MEMORANDUM

SUBJECT: **Setdown Report** for ZC #15-14, DC Water – Consolidated Planned Unit Development with Related Map Amendment from the CG/W-2 to CG/CR

dc  | **DC Water
Headquarters**

SUPPLEMENT TO JUNE 1, 2015 SUBMISSION

PLAZA & AUTOCOURT ILLUSTRATIVE

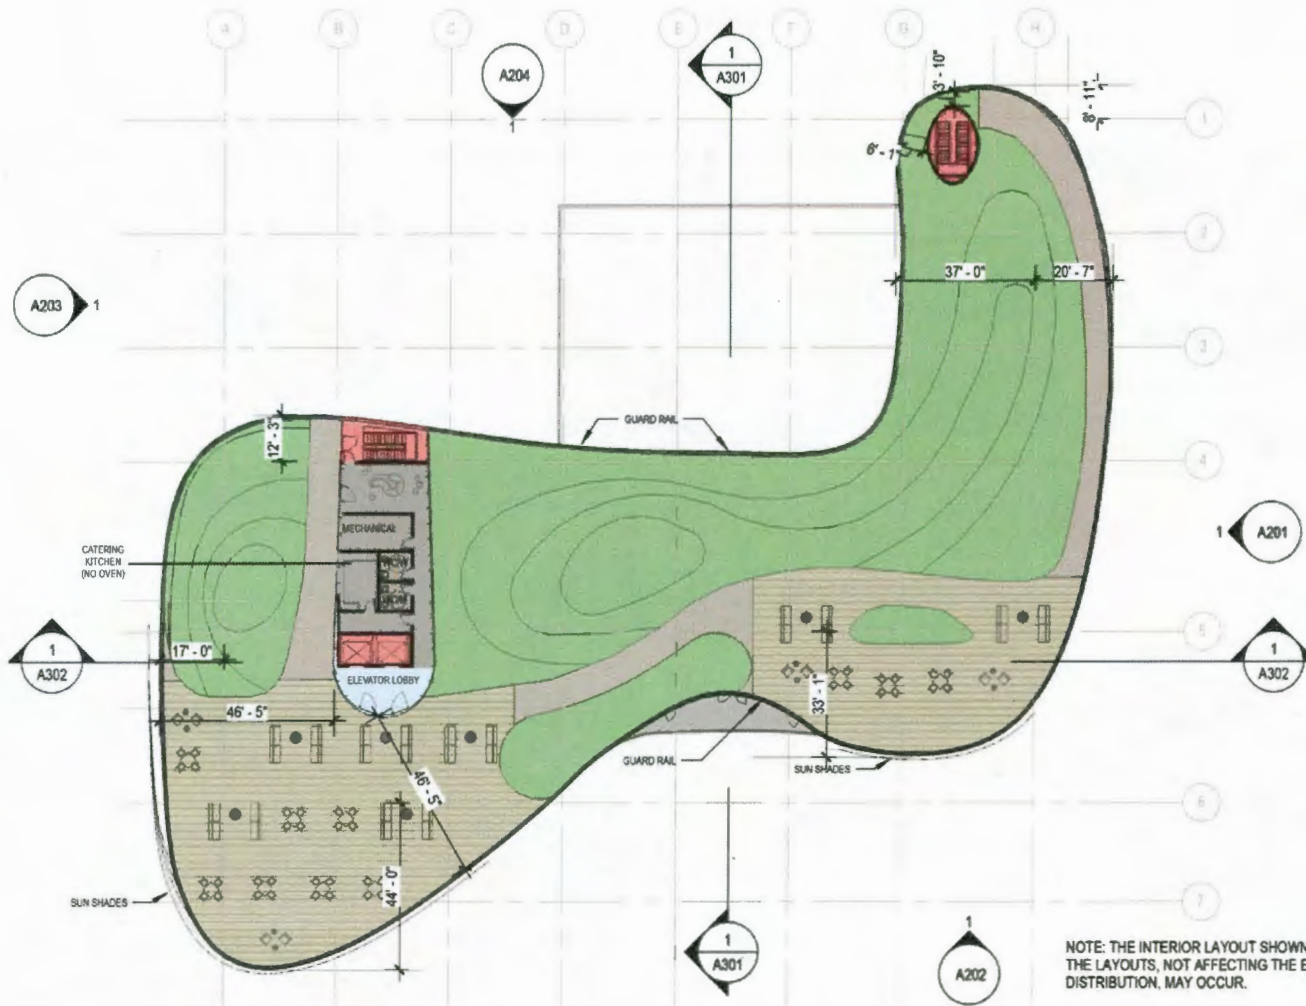
OP recommends that the applicant provide interior bike parking and maintenance within the building.

ROOF PLAN

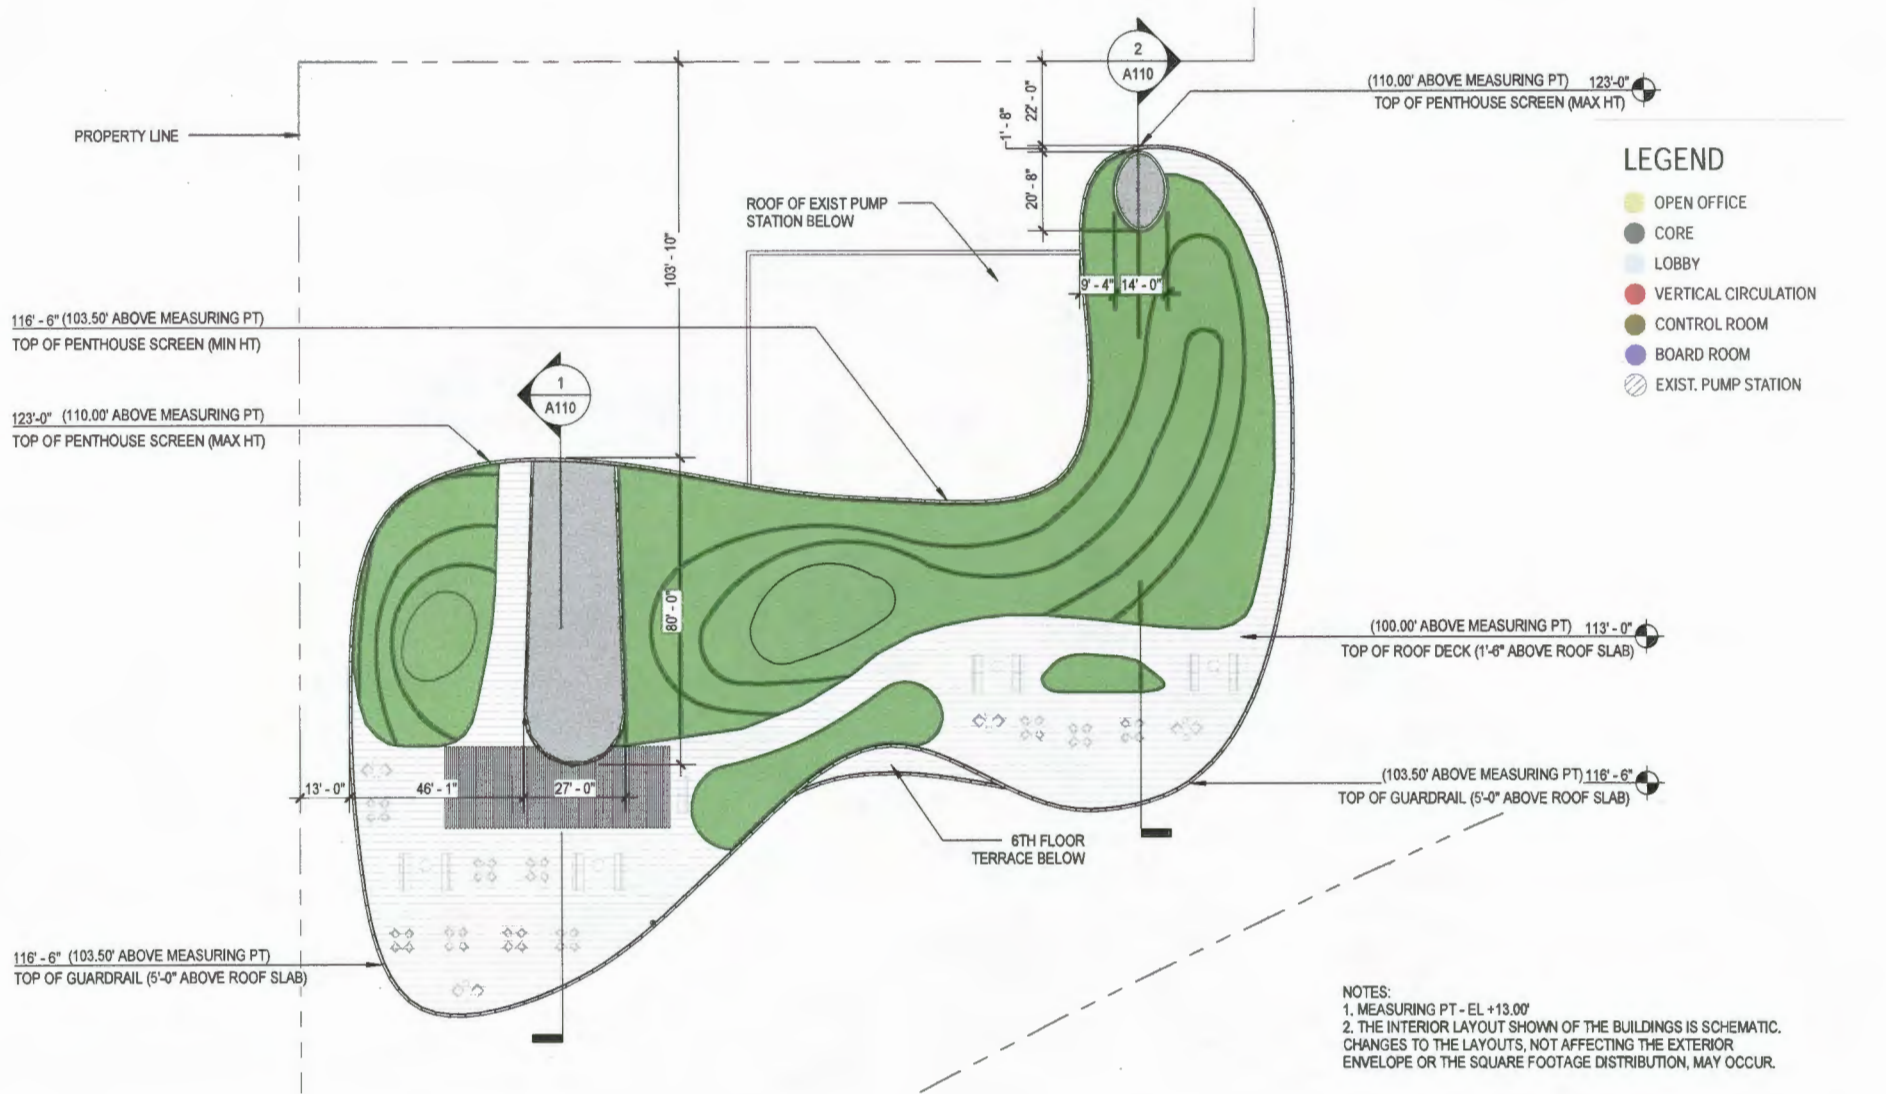
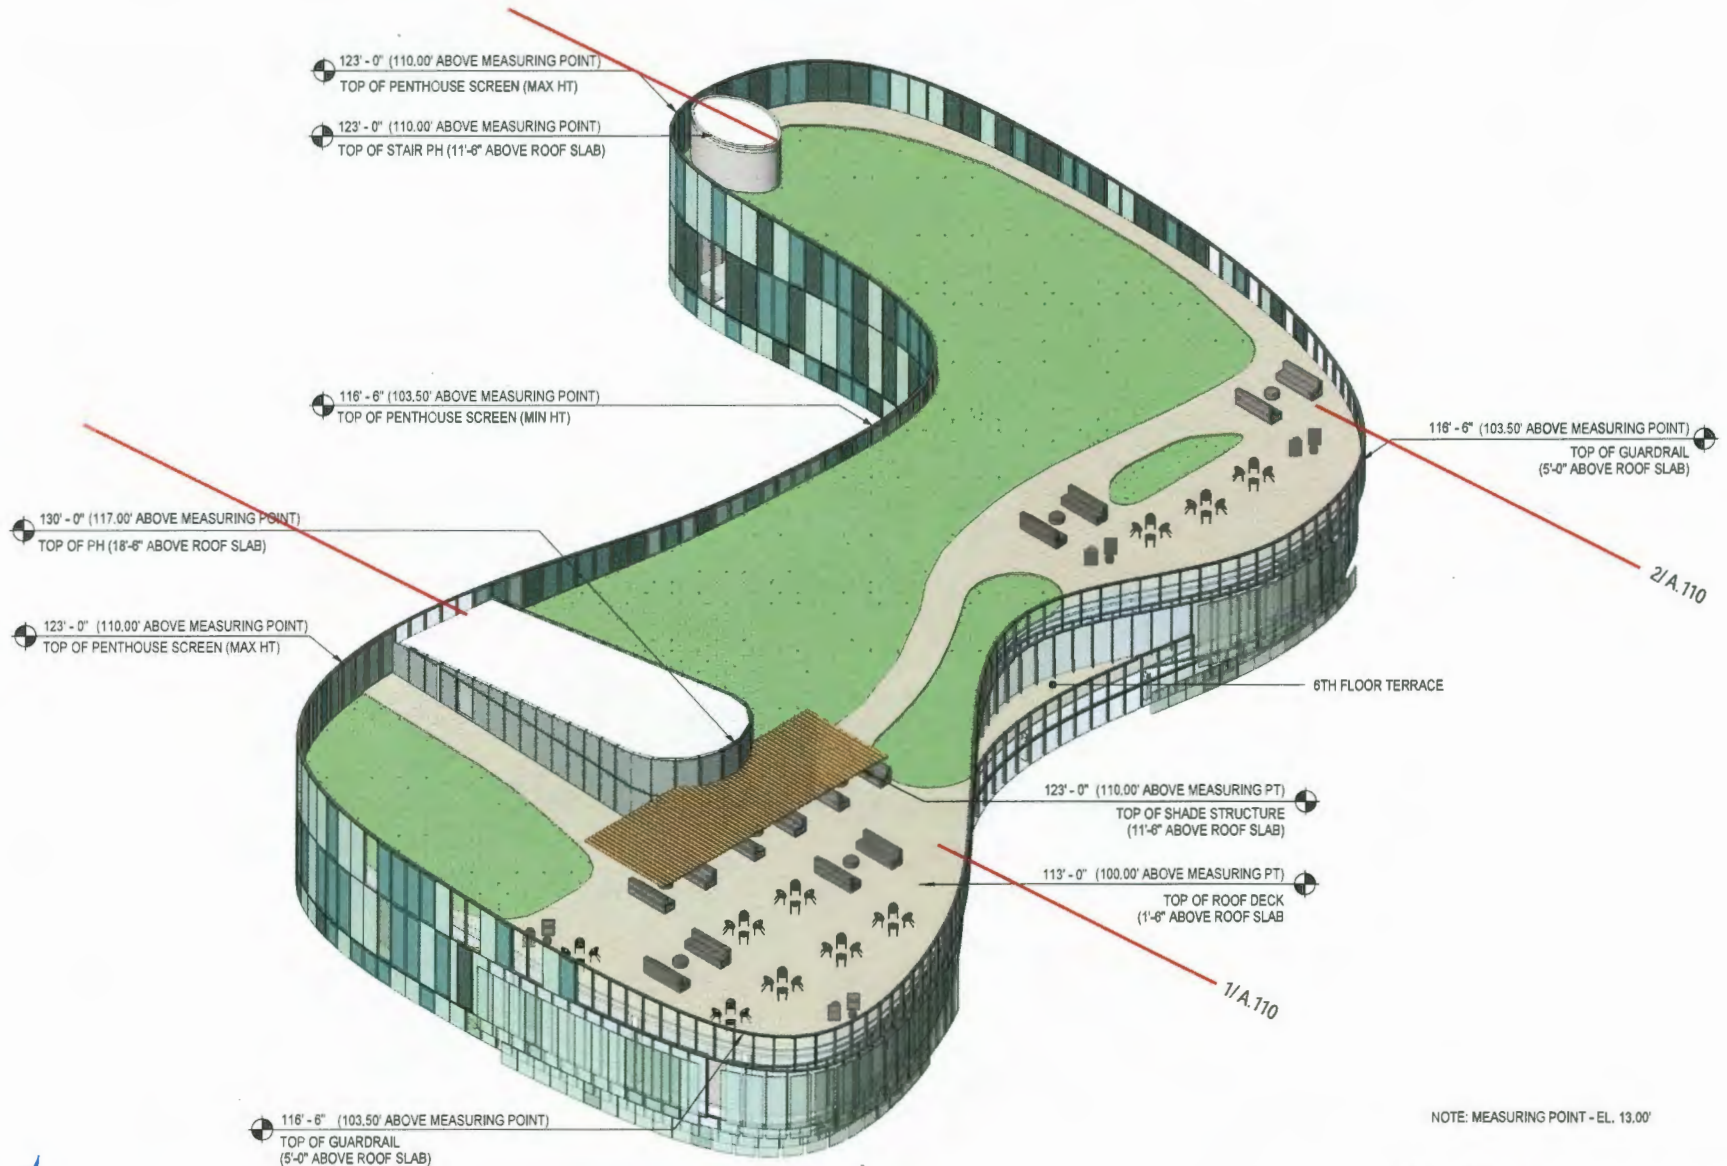
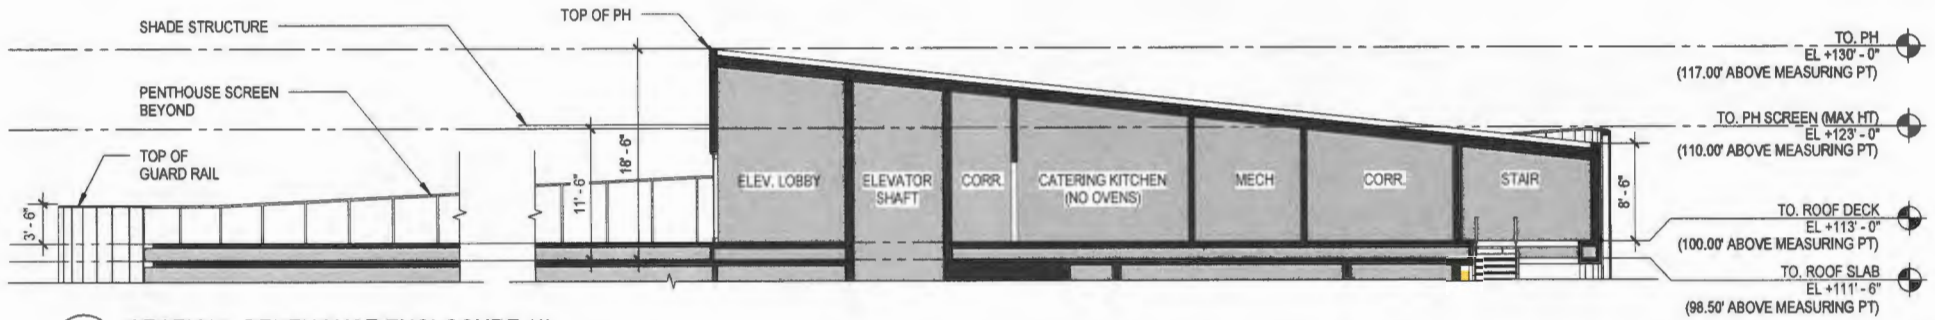
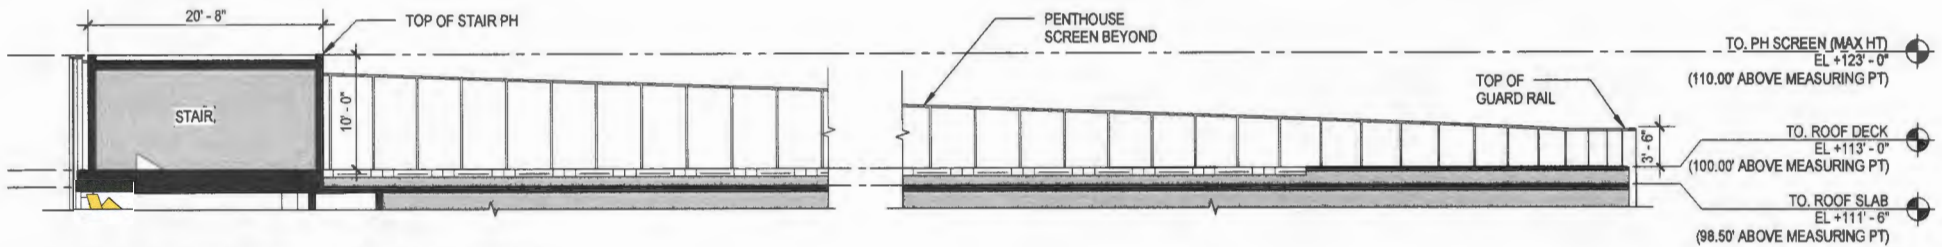
The applicant provided OP with additional plans as shown in Attachment 2 to assist in the review of the project, and OP is now requesting additional plans. OP is asking the applicant to provide renderings and perspectives to show how exactly the existing pumping station will be encapsulated and what that will look like as viewed from the west and north. OP also requests illustrations of the roof showing how it meets Code.

1. **Structure:** There is more than one structure on the roof
 2. **Setback:** The two roof structures are not set back at 1:1 distance from the surrounding walls

3. **Height:** The roof on the west side will have two heights due to elevator overrun

FENCE DIAGRAMS

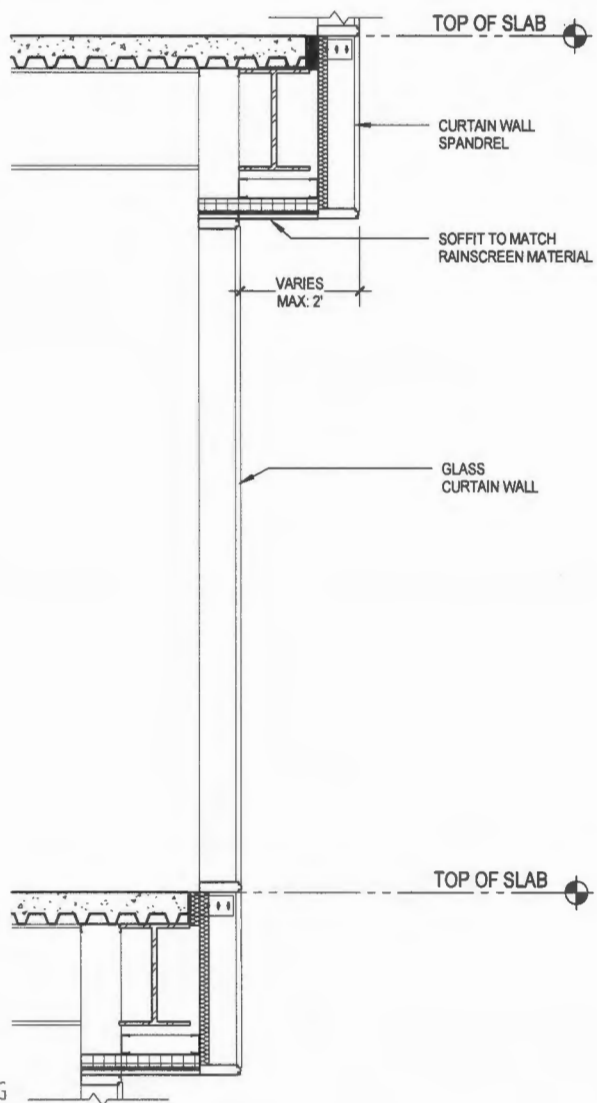
The proposed building will be distinctive and visible but the proposal shows the site surrounded almost entirely with chain link fencing. OP recommends that the applicant revise the plan to show “Clean Rivers” open metal fencing or some other continual fencing that is appropriate for this project. The fencing around this building should also be consistent with the fencing around the historic pumping station site.
